13 August 1985

Ms. Beth Riedlinger
Nuclear Regulatory Commission, Region V
1450 Maria Lane
Walnut Creek, CA 94596

Enclosed is a license amendment application for NRC License Number 53-23440-01. The changes requested are as follows:

Figure 1

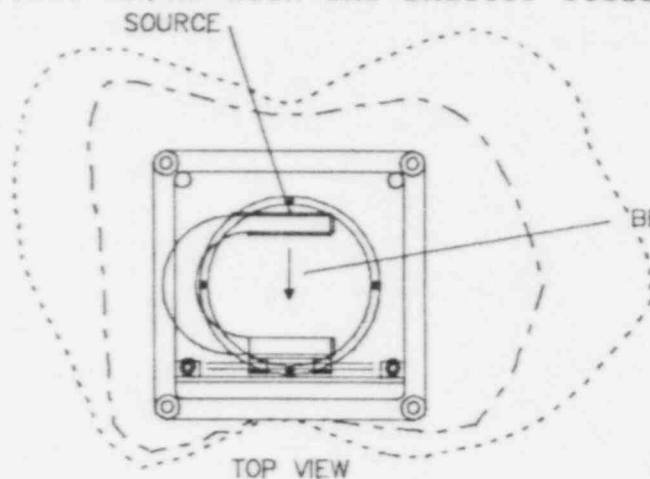
1. The activity per source is increased from 500 mCi to 800 mCi to be consistent with our custom device approval.
2. The radiation survey program has been changed. Isodose curves around the OsteoAnalyzer and normalized to 800 mCi are provided and the requirement to survey the OsteoAnalyzer each time a new source is installed has been deleted. The requirement to survey the storage cabinet each time another source is put in is also deleted, since the sources are shipped to us with a RADIOACTIVE - WHITE I label.
3. Paragraph 3.2.4. of the Hands-On Training has been deleted in accordance with your letter of 22 July 1985.

1.2. A detailed radiation survey has been performed with the source in an OsteoAnalyzer. The results of the survey are shown in Figure 1 to 3, normalized to a full strength 800 mCi source. A decay curve is also provided in Figure 4 so that the radiation levels for any source strength can be estimated from Figures 1 to 3.

Readings shown for shutter open and 800 mCi I-125 source in place. Readings taken with Victoreen 490 survey meter and 489-110 pancake probe. Survey meter calibrated specifically for I-125, using two separate sources and source activity data supplied by AECL. Calibration factor of 0.00009 mR/hr per cpm was used, based on gamma factor of 0.7 R-sq.cm./hr-mCi for I-125.

Readings on all surfaces of the analyzer were less than 0.001 mR/hr with the shutter closed.
